# Access Compliance Report

## Public Rights-of-Way

### (Curb Ramps)

Intersection ID: 49130	Main Street: AUBURN_HILL_LN	Cross Street: WILTSHIRE_RIDGE_RD	Location: SE
ADA ID: 031A47F17D21	Ramp Type: Perp	Initial Pass/Fail: Fail	Overall Compliance: No
Severity Score: 1.25			
Codes/Mitigation Info/Possible Solution		Field Measurements/Component Compliance

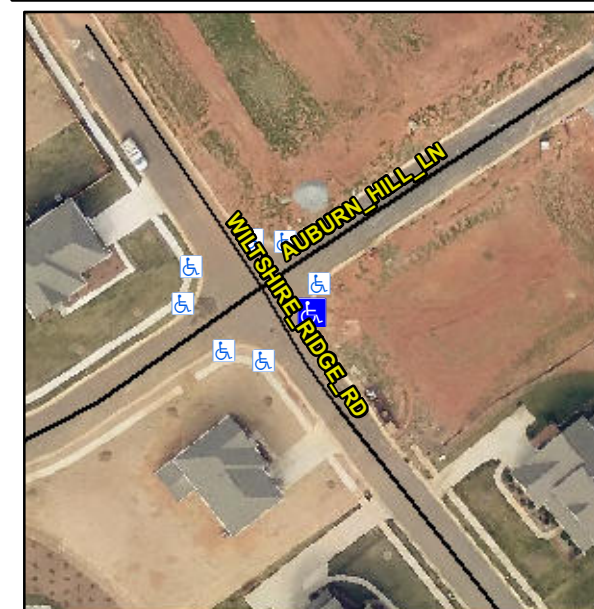
**Not Found, R304.5.3**

Compliance	Description	Data	Compliance	Description	Data
N/A	Ramp Length (in)	48.5	Yes	Ramp Slope (%)	7.1
Yes	Ramp Width (in)	48.0	No	Ramp XSlope (%)	3.3
N/A	Flare Type LT	N/A	N/A	Flare Type RT	N/A
N/A	Flare Slope LT (%)	N/A	N/A	Flare Slope RT (%)	N/A
N/A	Flare Traversable LT?	N/A	N/A	Flare Traversable RT?	N/A
N/A	Landing Length (in)	N/A	N/A	DWS Provided?	N/A
N/A	Landing Width (in)	N/A	N/A	DWS Contrast?	N/A
N/A	Landing Slope (%)	N/A	N/A	DWS Length (in)	N/A
N/A	Landing X Slope (%)	N/A	N/A	DWS Full Width?	N/A
N/A	Landing Curb? (Y/N)	N/A	N/A	DWS Offset (in)	N/A
N/A	Shared Landing?	N/A			
N/A	Gutter Ponding?	N/A	N/A	Gutter Slope (%)	N/A
N/A	Gutter Lip Ht (in)	N/A	N/A	Gutter X Slope (%)	N/A
N/A	Painted X Walk1?	No	N/A	Painted X Walk2?	N/A
	X Walk 1 Direction	To W		X Walk 2 Direction	N/A
N/A	X Walk 1 Width (in)	N/A	N/A	X Walk 2 Width (in)	N/A
	X Walk 1 Slope (%)	3.0		X Walk 2 Slope (%)	N/A
	X Walk 1 X Slope (%)	5.6		X Walk 2 X Slope (%)	N/A

**Remove & Replace Entire Ramp.**
